Record of Decision Taken Under Delegated Authority

Local Safety Scheme - Barratt Avenue Traffic Calming

Improvement

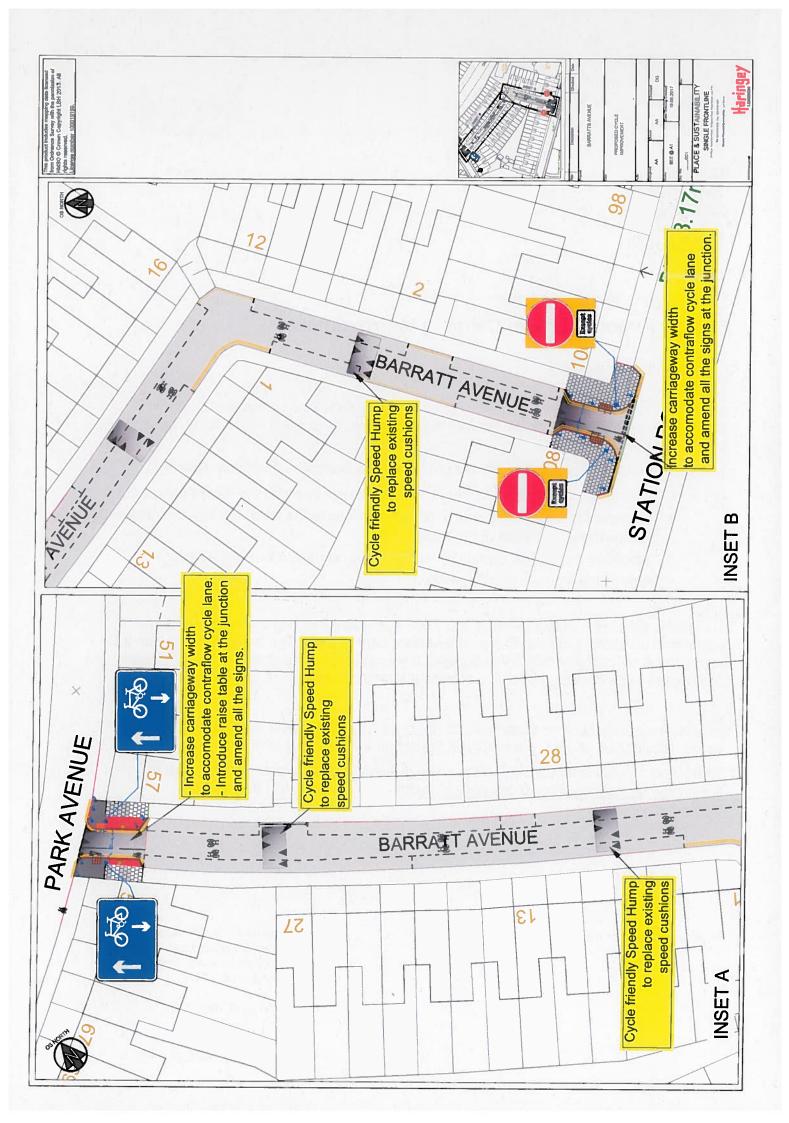
I object to a contraflow cycle lane. I think it is dangerous. Barratt Avenue is a narrow, one-way, street with parking on both sides. There isn't room for cars and for cycles travelling against the flow. Barratt Avenue is L shaped with a 90-degree blind corner, towards Station Road. This corner is next to St Paul's primary school. Traffic coming down Barratt Avenue from Park Avenue direction will not be able to see cyclists - and contraflow cyclists will not be able to see approaching traffic. It risks conditions for daily collisions, narrow squeaks, and ubiquitous road and cycle rage, right outside the entrance to a primary school. B: I object to increasing the carriageway width

at the junction of Barratt Avenue and Park Avenue because it will enable larger vehicles to enter Barratt Avenue from Park Avenue, and allow them to cut the corner from Park Avenue and enter at a faster speed. This will reduce road safety and increase noise nuisance. The current layout was implemented as part of the Safer Routes to School programme. How can it possibly be a good idea to get rid of the pavement buildouts and bollards that were introduced to calm traffic in Barratt Avenue? Widening the carriageway will reduce the effectiveness of traffic calming in the street. There are trees planted at the entrance to Barratt Avenue that were funded by the Local Area Assemblies following a submission from local residents. The current proposal to widen the carriageway would mean losing one or both of these trees, which is unacceptable. Residents didn't bid for trees in the expectation that the Council would rip them out within 10 years C: I object to the raised table at the junction of Barratt Avenue and Park Avenue. This is likely to cause vibration and noise nuisance, while making no difference to entry speeds into Barratt Avenue from Park Avenue; which are already controlled by the pavement buildouts and bollards. As Barratt Avenue is a one-way street there is no justification for a raised table. D: I object to full width sinusoidal speed humps. The existing speed cushions cause less noise and vibration, and so should be retained. The additional noise and clatter and vibrations from vehicles crossing and speeding away from full width humps is detrimental to residents. As Barratt Avenue is a narrow street this effect is amplified. Cyclists are currently cycling unimpeded in the gap between the existing cushions. E: Street signage: Barratt Avenue already has too much street clutter. Any amended street signage should make use of existing poles, and all redundant signs should be removed. Summary This proposal would reduce road safety for vehicles, cyclists and pedestrians, increase noise and vibration nuisance, impact negatively on residents in their dwellings, and tear up much loved community trees. This proposal would reduce the effectiveness of current traffic calming measures. It is dangerous. Why is the Council proposing spending money on a scheme that is prejudicial to Barratt Avenue residents' interests? I strongly object to the proposal.

My main objection to the scheme is the potential for serious accidents. You state that the proposed traffic plan "will improve safety for the benefit of all users." FIRSTLY: look at the plan of Barratt Avenue. It is a narrow L shaped street. On the sharp L shaped bend is St Paul's Primary School. This is a blind bend and any attempt to establish a two-way flow of traffic will inevitably result in serious and even fatal accidents, especially at start and end of school times. The widening of the junctions will further increase potential danger. At present vehicles are forced to slow down at the narrow entrance with Park Avenue, but any widening would simply increase the volume and speed of traffic, already using the road as a cut through. This traffic would then meet the cyclists head on at the dangerous bend by the

I object to the contraflow cycle lane, for the following reasons: A1. Barratt Avenue is a narrow street, with parking either side of the carriageway. The remaining carriageway width is not a great deal larger than the average car. It is not possible for cyclists travelling with the flow of traffic to be overtaken. In this regard the proposal for a formal contraflow cycle lane must be regarded as dangerous, and likely to precipitate arguments, road rage and accidents between drivers and cyclists. This cannot be what is intended. A2. Barratt Avenue has a sharp bend in it, prior to opening onto Station Road. It is a blind corner. Contraflow cyclists, present into the centre of the carriageway, particularly if street parking is full, would be exposed to the danger of head-on collision by vehicles travelling down the 'one-way street' from the Park Avenue end. Drivers would not be expecting to meet a cyclist in the carriageway around the blind corner. This is potentially very dangerous, and the scheme should not be attempting this. B: I object to the proposal to increase the carriageway width at the junction of Barratt Avenue and Park Avenue for the following reasons: B1. Widening the carriageway will result in the removal and loss of one or both of the street trees at the junction. These trees were requested by the local community and funded by the Local Area Assemblies in 2007/8. Their removal is unacceptable. B2. An increase in carriageway width will permit larger vehicles to enter and at a higher entry speed into Barratt Avenue from Park Avenue. This will result in greater noise nuisance and less road safety. The widening will encourage drivers to cut the corner from Park Avenue. The current junction layout of pavement buildouts and bollards was applied as part of the 20mph Safer Routes to School

programme and has been effective in calming traffic turning from Park Avenue. This is demonstrated by the high rate of attrition and damage to the bollards. The effectiveness will be reduced by widening the carriageway. B3. A contraflow cycle lane marking could be accommodated on the existing pavement buildouts without requiring the carriageway to be widened at this point. Precisely this arrangement has been put in place, 100m from this location, at the junction of St Michaels Terrace and Buckingham Road N22, facing The Starting Gate pub. This would be safer for cyclists exiting the junction, who would otherwise be perched in a narrow roadway, on the road side of the bollards, waiting to be hit. C: I object to the proposal to introduce a raised table at the junction of Barratt Avenue and Park Avenue for the following reasons: C1. A raised table is likely to cause vibration and noise nuisance to nearby dwellings, while making no difference to entry speeds into Barratt Avenue, which are already controlled by the pavement buildouts and bollards. As Barratt Avenue is a one-way street there can be no relevance of the junction table for exit from Barratt Avenue at this junction. C2. The current arrangement of pavement buildouts and bollards is in keeping with the character of the area, part of Conservation Area 10. The bollards and narrowed entrance carriageway reflect the quality of the Victorian period street, and enhance the Conservation Area. A raised table is not in keeping with the character of the area, and the table will have a negative impact on this character, for zero or marginal effect on vehicle behaviour. The proposal should therefore be rejected. D: I object to the proposal to introduce full width sinusoidal speed humps, for the following reasons: D1. The existing speed cushions are a compromise between control of vehicle speeds versus the noise and vibration nuisance of vehicles braking, traversing and accelerating away from the hump. Barratt Avenue is a comparatively narrow street

A- Transport for London (TfL) policy is that "there should be a presumption that contraflow cycling should be provided for in all one-way streets". Signs will be provided to clearly indicate that the road is a contra-flow cycle route so vehicles will be aware that cyclists are likely to be travelling towards them and can exercise caution. A safety audit has been carried out on the proposals and no issues where identified.

B – Due to the concerns raised about widening The Barratt Avenue and Park Avenue junction, we will now not be increasing the carriageway width. The proposal has now been amended to incorporate a cycle lane on the footway at the junction to allow cycle access. Existing trees will be set aside and replanted.

C – The raised junction entry table at the Park Avenue/ Barratt Avenue junction will reduce the speed of traffic entering and exiting Barratt Avenue which will improve pedestrian and cyclist safety and accessibility at that location.

Response: Due to the concerns raised about widening The Barratt Avenue and Park Avenue junction, we will now not be increasing the carriageway width. The proposal has now been amended to incorporate a cycle lane on the footway at the junction to allow cycle access. A raised junction entry table will also be introduced at the junction to reduce entry and exit speeds which will improve safety and accessibility for cyclists and pedestrians. Sinusoidal speed humps offer road users less discomfort and it allows cyclist to maintain speed. The sinusoidal profile of the hump will have a gentler than usual incline and will reduce the need for vehicles, such as buses to accelerate and decelerate thus reducing noise and vibrations. This is the HCC's preferred type of vertical traffic calming.

A1 & A2 - Transport for London (TfL) policy is that "there should be a presumption that contraflow cycling should be provided for in all one-way streets". Signs will be provided to clearly indicate that the road is a contra-flow cycle route so vehicles will be aware that cyclists are likely to be travelling towards them and can exercise caution. A safety audit has been carried out on the proposals and no issues where identified.

B1 - Existing trees will be set aside and replanted.

B2 & B3 – Due to the concerns raised about widening The Barratt Avenue and Park Avenue junction, we will now not be increasing the carriageway width. The proposal has now been amended to incorporate a cycle lane on the footway at the junction to allow cycle access.

C1 - The raised junction entry table at the Park Avenue/ Barratt Avenue junction will reduce the speed of traffic entering and exiting Barratt Avenue which will improve pedestrian and cyclist safety and accessibility at that location.
